# Service Bulletin

BULLETIN # 277

## WELDARC 145I

### VRD ACTIVATION

Figure 1 - Front display PCB VRD enable/disable DIP switch

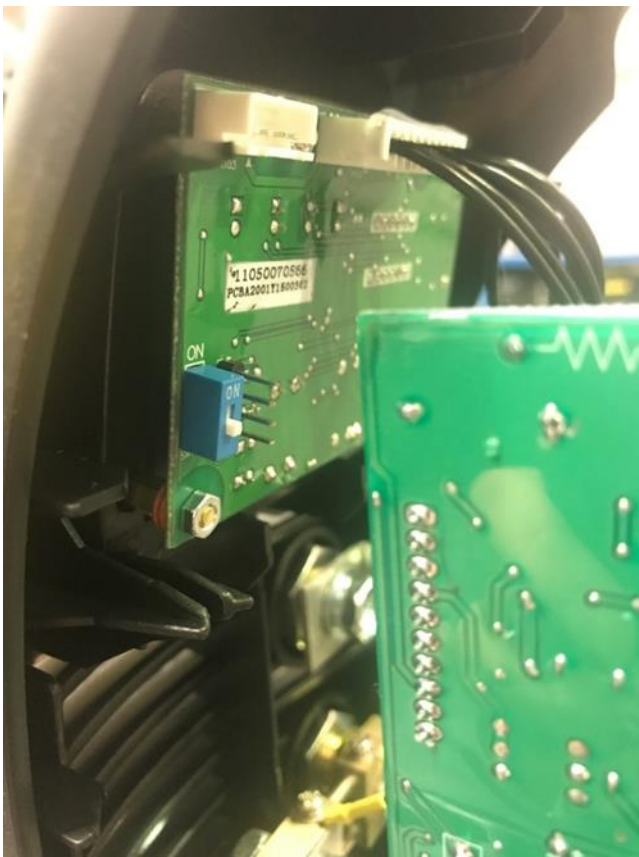
The original design allowed the VRD to be enabled/disabled by moving the DIP switch on the rear of the front display PCB.

Move the switch to the ON position to enable VRD. Move away from ON to disable VRD (See Figure 1).

Figure 4 - Additional resistor fitted in parallel with original

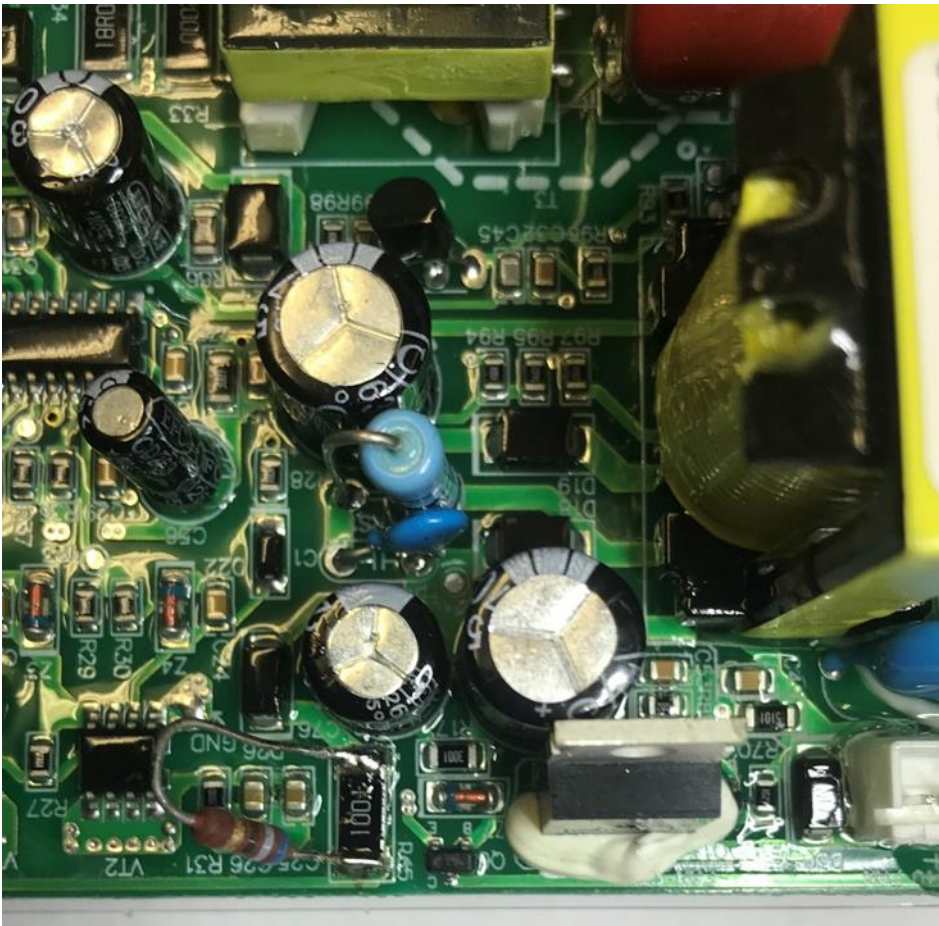
Once the modification is completed, the machine should be functionally tested to prove operation. The VRD should be tested to ensure success of the modification and compliance to appropriate standards.
